Received by WCD-Sy18/2024 8:55:19 AM U.S. Department of the Interior		Sundry Print Report 01/18/2024
BUREAU OF LAND MANAGEMENT		200-01-202
Well Name: RIDGE NOSE FEDERAL COM	Well Location: T26S / R29E / SEC 31 / SWNE / 32.000509 / -104.022282	County or Parish/State: EDDY / NM
Well Number: 1H	Type of Well: OIL WELL	Allottee or Tribe Name:
Lease Number: NMNM121474	Unit or CA Name: RIDGE NOSE FED COM 1H	Unit or CA Number: NMNM134623
US Well Number: 3001542391	Well Status: Producing Oil Well	Operator: COG PRODUCTION

Sundry ID: 2765587

Type of Action: Plug and Abandonment

Permanent Abandonment of Federal Wells Conditions of Approval

Nuthor: Leo Gallegos Well No. 1H Ridge Nose Fed Com Well No. 1H Brushy Draw Del API #: 30-015-42391 County Eddy Location 200' FSL & 2310' FEL State NM Sec 6-T26S-R29E Prod Csr 55 P140 17 13 030 7 7/8 2 750 4,020'					1 6	Description	O.D.	Grade	Weiaht	Depth	Hole	Cmt Sx	TOC	erv

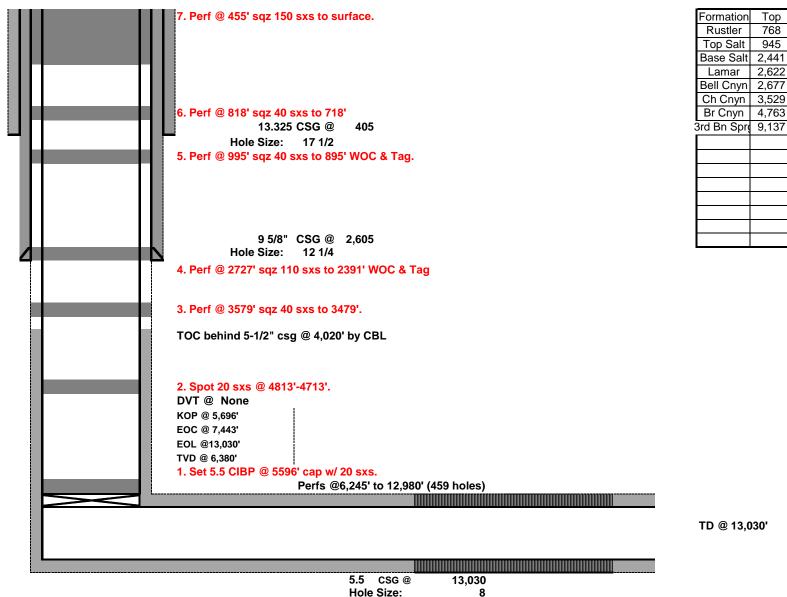
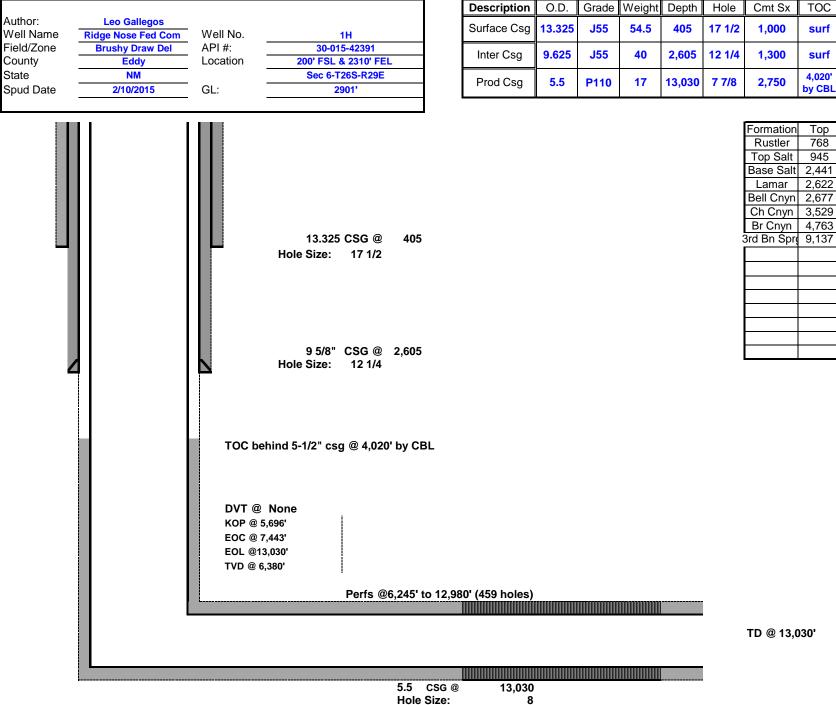
Procedure Description: 1. Set 5.5" CIBP @ 5596' cap w/ 20 sxs cmt on top WOC & Tag. 2. Spot 20 sxs @ 4813'-4713'. 3. Perf/Sqz 40 sxs @ 3579'-3479'. 4. Perf/Sqz 110 sxs @ 2727'-2391' WOC & Tag. 5. Perf/Sqz 40 sxs @ 995'-895' WOC & Tag. 6. Perf/Sqz 40 sxs @ 818'-718' 7. Perf/Circ 150 sxs from 455'-surface. 8. Cut off well head, verify cmt @ surface weld on Dry Hole Marker.

- 1. Set 5.5" CIBP @ 5596' cap w/ 25 sxs cmt on top WOC & Tag.
- 2. Spot 25 sxs @ 4813'-4713'.
- 3. Perf/Sqz 40 sxs @ 3579'-3479'. WOC & Tag.
- 4. Perf/Sqz 110 sxs @ 2727'-2366' WOC & Tag.
- 5. 5. Perf @ 995' sqz 296 sxs to 0' Verify circulated to surface
- 6. Cut off well head, verify cmt @ surface weld on Dry Hole Marker.

Sundry ID	2765587					
Plug Type	Тор	Bottom	Length	Tag	Sack	Notes
Surface Plug	0.00	995.00	995.00	Verify circulated	296	Perf and Squeeze
Shoe Plug	0.00	995.00	995.00	to surface	SXS	Fell and Squeeze
Top of Salt @ 945	0.00	995.00	995.00	WOC and		
Base of Salt @ 2441	2366.00	2727.00	361.00			
Shoe Plug	2366.00	2727.00	361.00	WOC and Tag	100 sxs	Perf and Squeeze
Delaware @ 2677	2366.00					
		TOC @ 4				
CIBP Plug	5561.00	5596.00		WOC and Tag	25 sxs	500psi leak test 30 min
